FIELD INSPECTION

Project Name:	Mountain Valley Pipeline	Inspector:	Matthew Grant
Inspection Date:	Thursday, September 26, 2019	Project Contact:	Brian Clauto
Spread: Montgomery Co. AR MN 278.01 MP237.3-235.7	Spread H	Weather (Wet/Dry/Rain):	Dry

FIELD INSPECTION PHOTO LOG

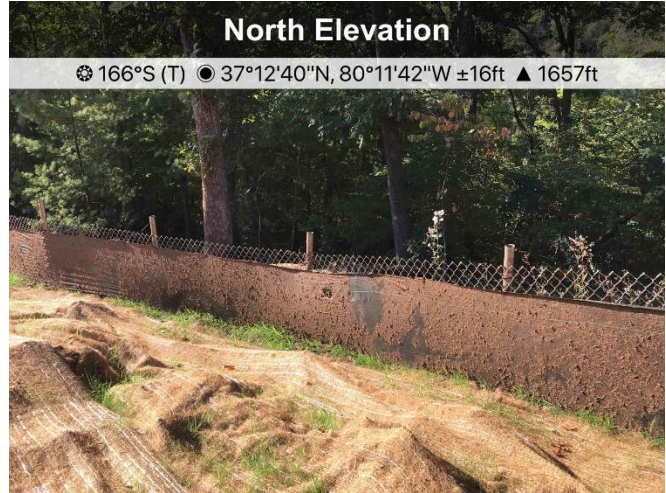
- Inspected designated streams & wetlands included: W-CD11-UP, S-EF19
- ECD's were in place for active construction and functioning at designated streams.
- St12539+15 SSF requires maintenance
- St12533+62 CFS requires maintenance
- Areas of sediment that have been previously reported include: S-EF19, St12529+64, St12530+21, W-EF5PFO, S-EF20a

- Fig. 2. St12539+15 SSF has a hole in it and requires maintenance.

- Fig. 3 St12533+62 CFS has a hole in it and requires maintenance.

Recommend Corrective Action: Maintain and install all controls per the approved plan and specs

Deadline: Within 24hr notification
